1. Outer Harbor Greenway – Ongoing Development: Completing the Outer Harbor Greenway route through the Port CBD and Waterfront should be considered a priority by PA/E Council for 2021. PortBUG recommends that additional & ongoing initiatives should include:

Port Adelaide CBD

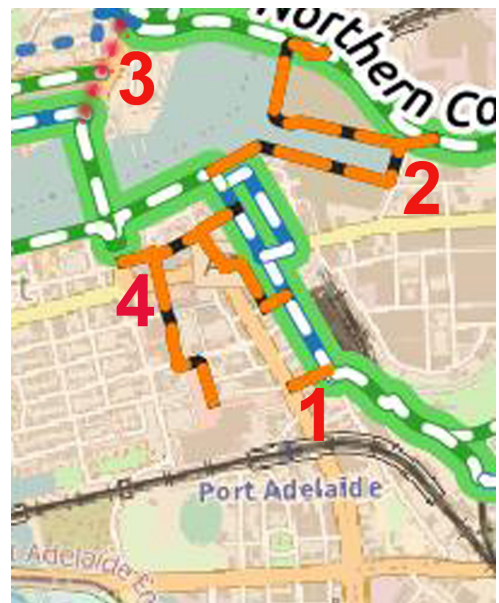
- **Preliminary project work for the Rosewater Loop:** This could include soil testing, investigation of contamination management, ownership transfer, planning and costing etc. *See '2' at right.*
- **Gilman Rail Reserve Crossing at Evans St:** Evans Street is divided into two sections at Rosewater. At present there are informal 'made' access points on the northern and southern sides that allow pedestrians and bicycle users to access the similarly informal sections of the Gilman-to-Ottoway pathway, proposed as the route for the 'Rosewater Loop' project. Creating formal access points here would assist local residents to make much more secure and convenient use of this important route, particularly for the young, elderly and inform. Requires new ramps, stretches of pathway, signage and - eventually – lighting.

4. Interim Access - PREXY/Diver Derrick Bikeway to the Port Waterfront: While plans allow for eventual construction of pedestrian and bike access to St Vincent St via WauWa Street, temporary access needs to be maintained over the course of housing development. This will require signs, ramps and possibly short lengths of paved pathway. *See 'P94' below & '2' at right.*

5. Further development of the Mersey Road Bikeway: This could include signage, better continuity through or around the new naval ship-building precinct, interpretive signage and tourism linkages etc. *See '1' at right.*

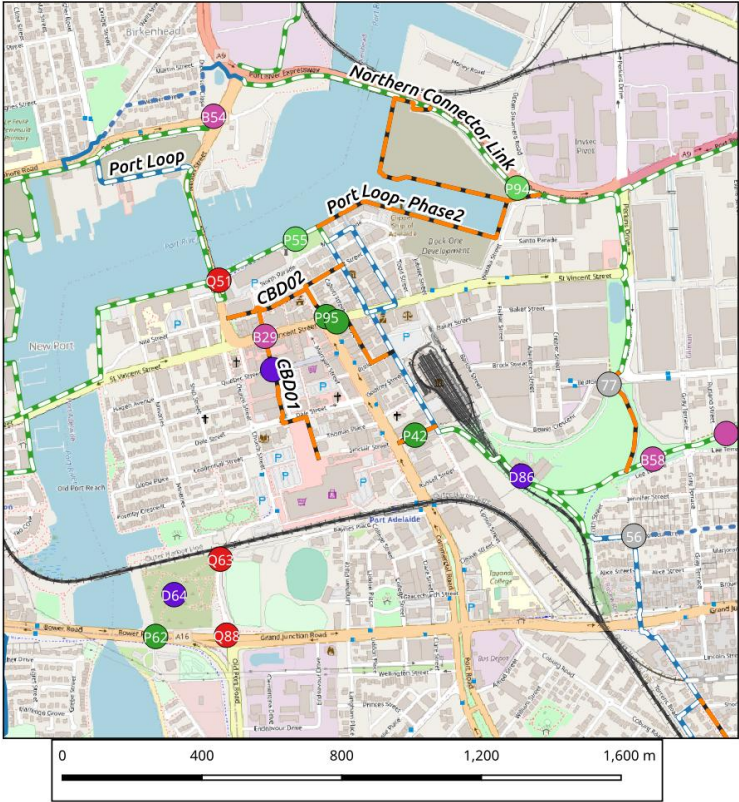
id	Description
56	Approach from secondary route along Rosetta St? Margaret Tce secondary route needs sign to denote entry to OHG
77	Access between offr path on Perkins Drive and the connection through Rosewater to the OHG is impeded by steel barrier
B54	Needs connection to Port Loop
B29	Restore previous crossing
P42	Possibl public walkway - owned by DPTI
P55	Conflict between cycling and boat queues needs to be addressed
B58	Deteriorated surface
P62	People from Semaphore Park going to Port CBD need safe point to cross
Q63	Entrance coincides with tree blocking path
D64	Track is well used but surface is poor - muddy in winter. Needs gravel surface
D86	Trees needed to shade this section
Q88	Dangerous road surface in cycling lane needs repair
Q51	Blind corner - mirror needed
D92	Pedestrian Crossing near Farmer Joe's is needed urgently
P94	From this point one can ride offr almost 50 km to Gawler. How long do we have to wait for this development to free up access to/from the Port

P95	Protected bike kerbside standing zone; It may be possible to accomodate a special bike/pedestrian facility
P96	Redesigned shared path zone on footpath
